SERVICE BULLETIN
OPTIONAL**N° 139-371****DATE:** May 9, 2014**REV. :** A - August 4, 2023

TITLE**ATA 25 – INSTALLATION OF HOIST PENDANT VARIANT P/N 3G2591A08211****REVISION LOG**

This Service Bulletin is issued in order to provide all necessary instructions on how to perform the installation of hoist pendant variant P/N 3G2591A08211.

Figure 1

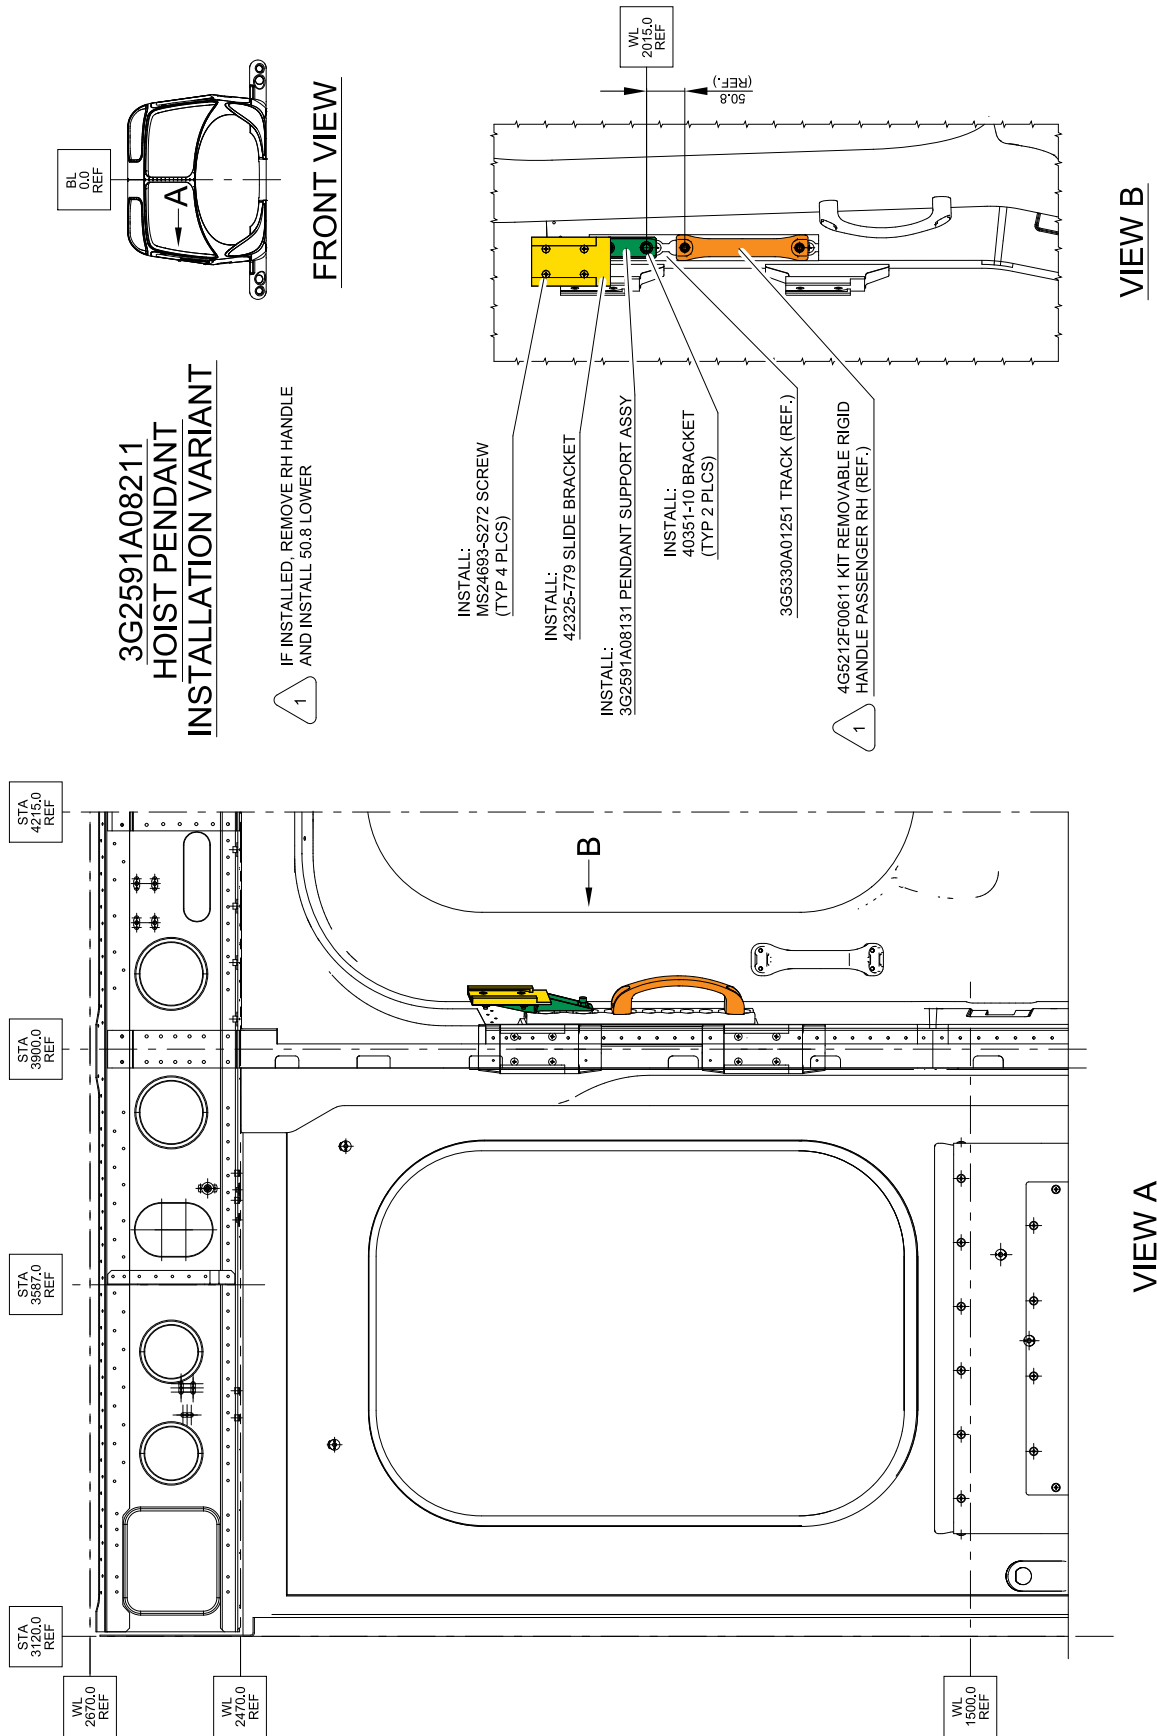
The hoist pendant variant P/N 3G2591A08211 consists of a new pendant support on the passenger door frame. The new support is intended to be used during hoist operation to hold the pendant in a position easier to be reached.

- 2.1 In accordance with AMP DM 39-A-52-15-01-00A-520A-K and with reference to Figure 1 View B, temporarily remove the passenger RH handle, retain all attaching hardware for later reuse.
 - 2.2 In accordance with AMP DM 39-A-52-15-01-00A-720A-K and with reference to Figure 1 View B, reinstall the passenger RH handle 50.8 mm lower on the tie down fitting frame track P/N 3G5330A01251, by means of the existing hardware.
 - 2.3 With reference to Figure 1 View B, install pendant support assy P/N 3G2591A08131 by means of n°2 brackets P/N 40351-10.
 - 2.4 With reference to Figure 1 View B, install on pendant support assy the slide bracket P/N 42325-779 by means of n°4 screws P/N MS24693-S272.
3. In accordance with weight and balance changes, update the Chart A (see Rotorcraft Flight Manual, Part II, section 6).
